World Forum for Harmonization of Vehicle Regulations

**1958 Agreement – Consideration of draft amendments
to existing Regulations submitted by GRSP**

**Proposal for the 03 series of amendments to Regulation
No. 80 (Strength of seats and their anchorages)**

Figure 1
Positioning requirements for side-facing seats

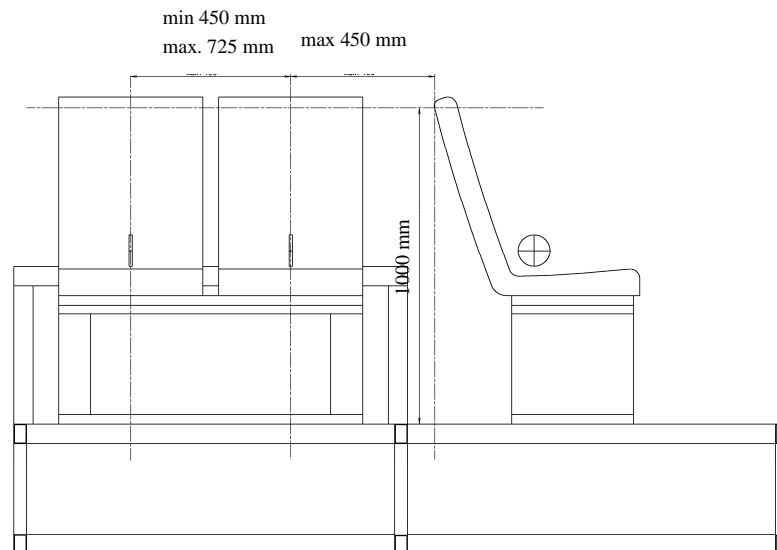
7.4.3. The horizontal distance between the H-point line between two adjacent side facing seats shall not exceed 725 mm and shall not be less than 450 mm, measured horizontally between the vertical longitudinal planes passing through the centres of these seating positions, (see Appendix 7, figure 1); and

1. The distance between the foremost side-facing seat and the vehicle part forward of this foremost side-facing seat shall not exceed 450 mm. All measurements are to be taken 1000 mm above the reference plane of the foremost side-facing seat (see figure 1).

Figure 2

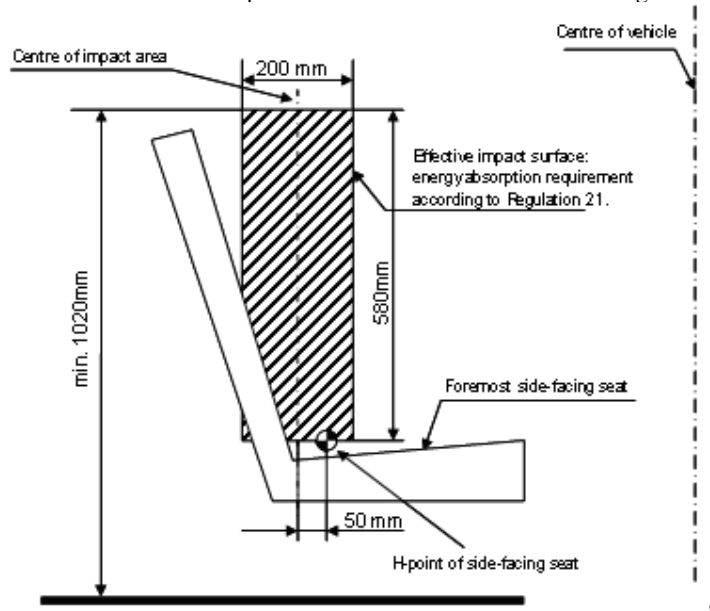
2. The vehicle part (e.g. partition, wall or seat back of a forward facing seat) in front of the foremost side-facing seat shall fulfil the following requirements in order to safeguard the passenger in that foremost side-facing seat (see figure 2):

- 2.1. The height of the vehicle part, based on the reference plane of the foremost side-facing seat, must not be less than 1,020 mm; and
 - 2.2. The effective impact surface of the vehicle part has a width of 200 mm and a height of 580 mm. This surface shall be positioned so that the vertical centre-line is located 50 mm behind the H-point of the foremost side-facing seat; and

- 2.3. The corresponding surface of the vehicle part in place projected onto a vertical plane through this H-point, shall cover at least 95 per cent of the effective impact surface. This vehicle part shall fulfil the energy absorption requirement by Appendix 6.

- 2.3.1. If there is a gap in the corresponding surface (typically two forward-facing seats with a gap in between) a distance shall be determined for each gap by means of a sphere having a diameter of 165 mm. The sphere shall be put into contact with the gap in a point of the gap area which allows the maximum

sphere intrusion, considering no load is to be applied. The distance between the two points of contact of the sphere must be less than 60 mm;

- "1. Arrangements in the approval mark for a seat

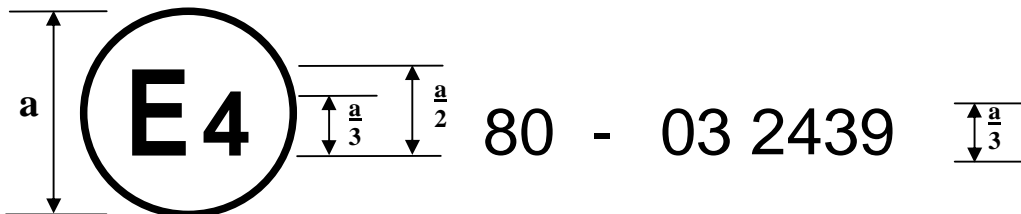
The above approval mark affixed to a seat shows that the seat type concerned has, with regard to the strength of the seats, the test being carried out in accordance with paragraph 2 of Annex 4, been approved in the Netherlands (E4) under number 032439. The approval number indicates that the approval was granted in accordance with the requirements of Regulation No. 80 as amended by the 03 series of amendments.

2. Arrangements in the approval mark for a vehicle type

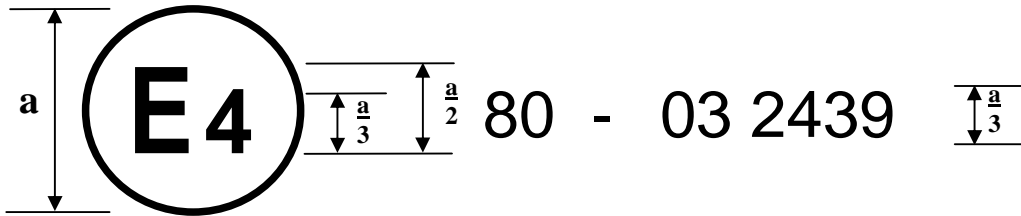
The above approval mark, affixed to a vehicle, shows that this type of vehicle has been approved in the Netherlands (E4) under number 032439 with regard to the strength of the anchorages on the vehicle. The approval number indicates that the approval was granted in accordance with the requirements of Regulation No. 80 as amended by the 03 series of amendments."
